CITY OF KELOWNA

MEMORANDUM

Date: April 10, 2025
File No.: DP25-0033
To: Development Planning Dept (CM)
From: Development Engineering Dept
Subject: 2091 Harvey Ave

The Development Engineering Department has the following comments associated with this Development Permit Application for a commercial building development.

1 PROPOSED ENLARGED SITE PLAN
A-1.2 SCALE: 3/32" = 1'-0"

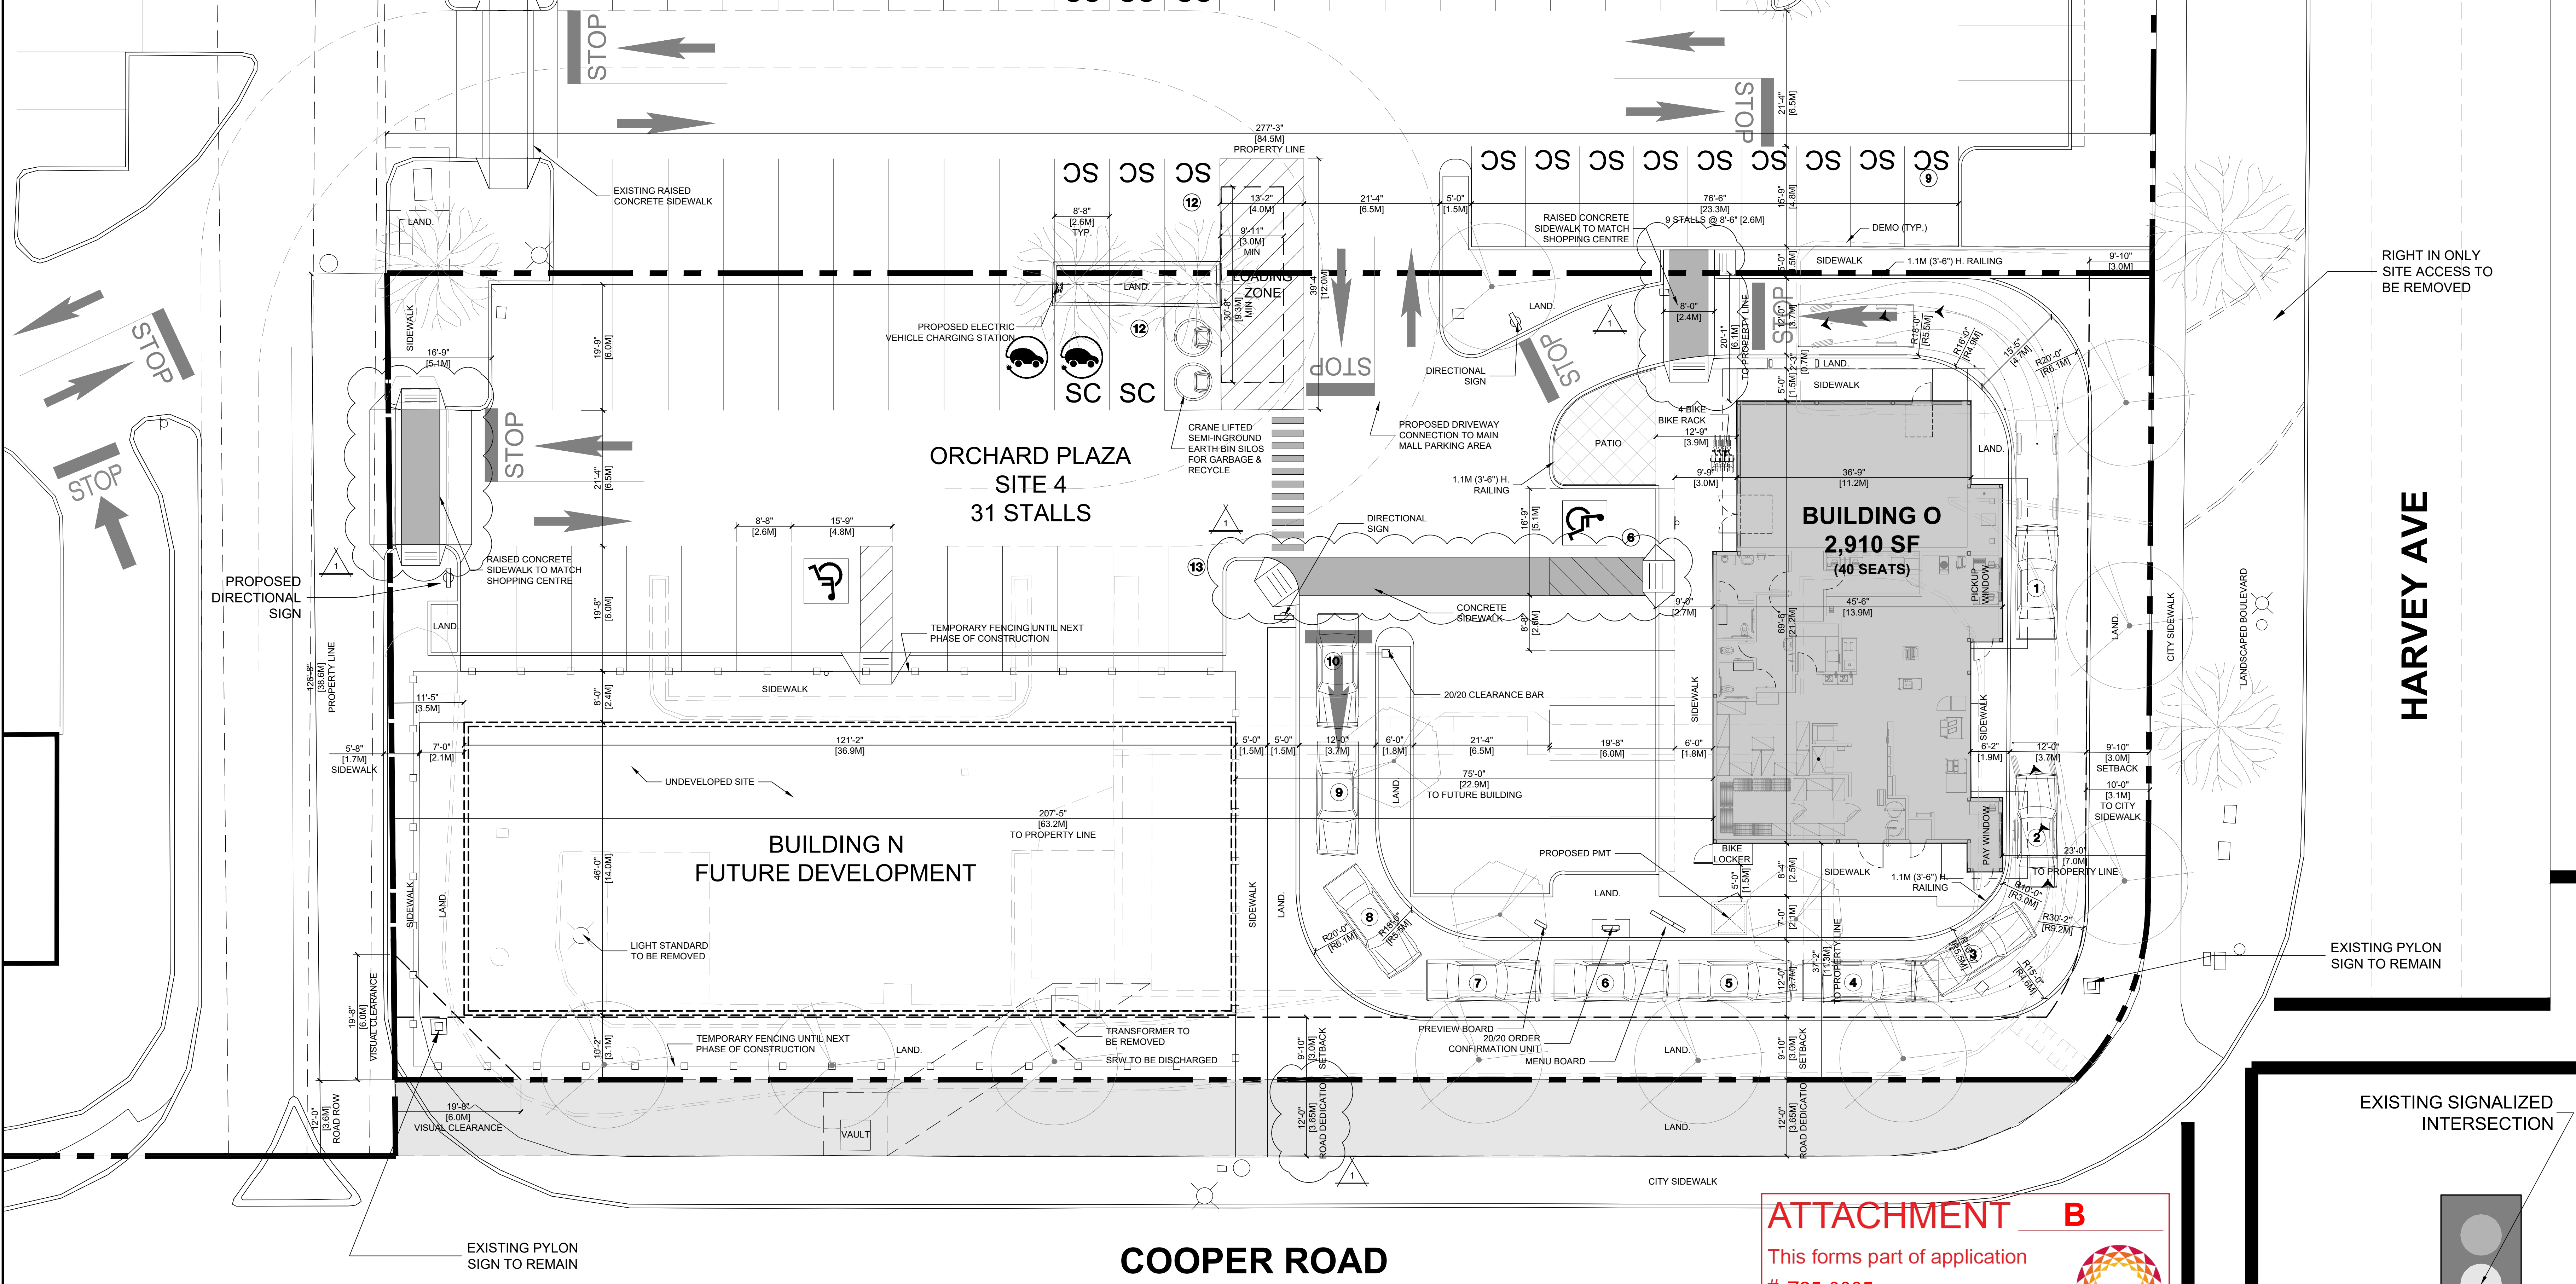
- a. The existing site is access from Cooper through the 1840-1920 Cooper Rd property to the south is able to adequately service the site. The existing driveways off Harvey Ave must be removed and replaced with irrigated landscaping with a tree. It is preferred that no additional accesses from Cooper are permitted.

- i. The proposed site plan and landscape plan appear consistent with these requirements.
- b. Approximately 3.65 m road dedication along the entire frontage of Cooper Rd is required to achieve a half ROW width of 16.75 m in accordance with OCP Functional Road Classification objectives and Bylaw 7900 Typical Road Sections.

- i. The existing 40' (12.192 m) radius corner rounding must be modified to be tangent to the resultant property line of this dedication. The radius may be reduced by the width of the dedication to approximately 8.5 m to maintain the existing tangent point on Harvey Ave.

- ii. Confirm the existing pylon sign does not overhang/encroach into the ROW, if remaining.
- c. The existing stairway from the sidewalk to drive-thru aisle at the north-east corner of the site is to be removed as shown on the landscape plan.

- d. The mid-lot sidewalk connection into the site is supported, but should be a minimum of 1.5 m wide to meet constrained-accessibility standards.
- e. Proposed on-site crosswalks and letdowns should align, not conflict with or direct pedestrians into parking stalls or loading zones.
